STAFF REPORT: FEBRUARY 12, 2025 REGULAR MEETING **PREPARED BY: T. BOSCARINO**
APPLICATION NUMBER: HDC2024-00700 (VIOLATION #24-891)
ADDRESS: 4340 GLENDALE
HISTORIC DISTRICT: RUSSELL WOODS-SULLIVAN
APPLICANT: KARINA LABARCA
PROPERTY OWNER: AFIWI LLC
DATE OF PROVISIONALLY COMPLETE APPLICATION: DECEMBER 10, 2024
DATE OF STAFF SITE VISIT: FEBRUARY 5, 2025

SCOPE: REPLACE WOOD WINDOWS (WORK COMPLETED WITHOUT APPROVAL) WITH ALUMINUM-CLAD WOOD WINDOWS

Image from 2024 application documents showing the two remaining historic windows on the house (partly hidden behind the patio heater).

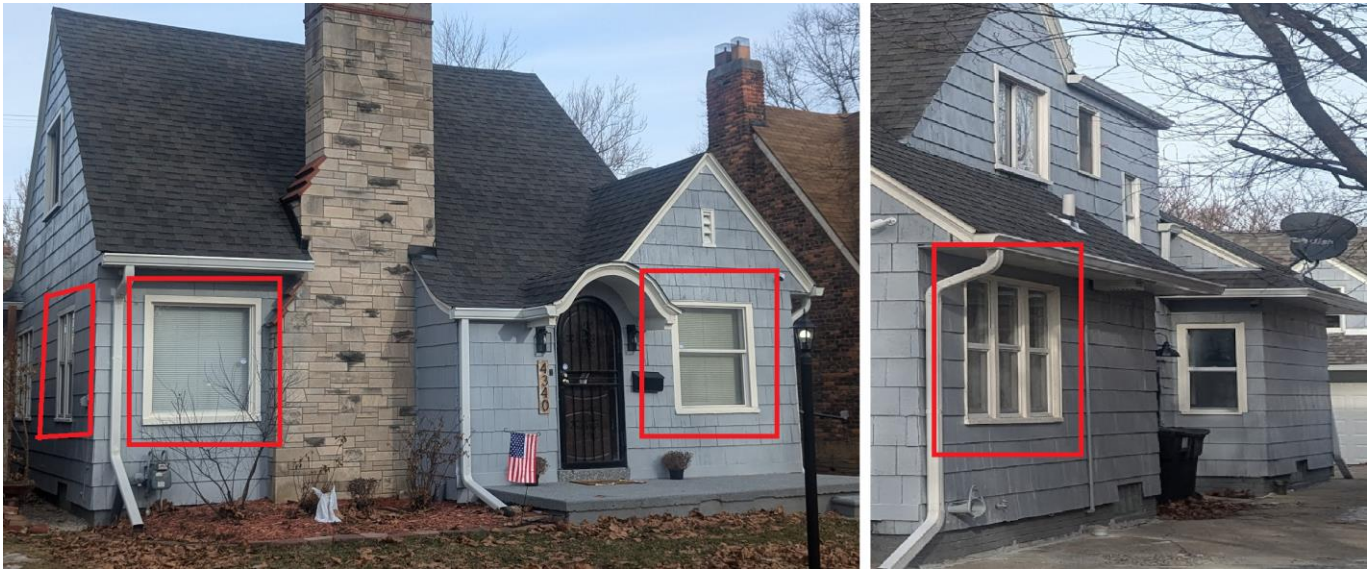
During the spring of 2024, the present applicants removed additional original windows from the sides and rear of the dwelling and replaced some of the earlier vinyl windows on the facade. Some of these windows fill the width of the original window openings, whereas others required dimensional modifications to the rough openings. The windows are a mix of double-hung, picture, and slider windows. Two window openings, one at the east wall and one at the rear, were infilled entirely. Three remaining original wood windows—a paired set on the rear and one on the garage—were still in place at that time and remain in place today.

Openings proposed for replacement with aluminum-clad wood windows marked with red boxes. February 2024 photos by staff.

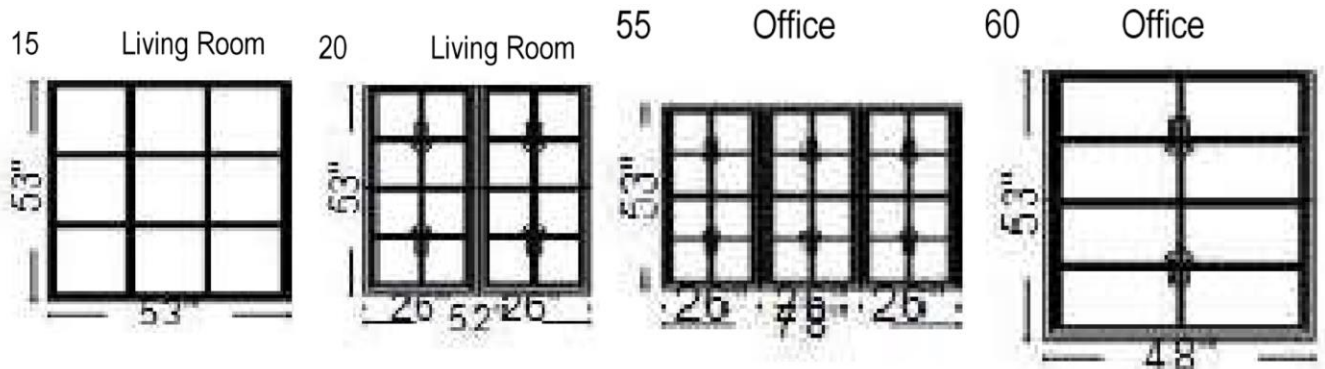
- Staff’s ability to assess the appropriateness of the proposed replacement windows is hindered by a lack of information on the appearance of the historic windows. The four openings appear to have been filled as follows, from east to west (right to left on the photos above):

- Frontmost opening on east elevation: Triple-ganged, mullioned sash windows, as seen in the 1999 photo. Based on other known historic windows, it is likely that a four-over-four muntin

pattern existed, but this is not certain.

- Easternmost opening on front (south) elevation: Most likely, double-ganged, four-over-four, sash windows, as seen in the 1999 photo. A pair of eight-pane casement windows is also possible, as this would not be inconsistent with the house's Tudor style.
- Westernmost opening on the front (south) elevation: Same as above.
- Frontmost opening on west elevation: The original configuration is not known.
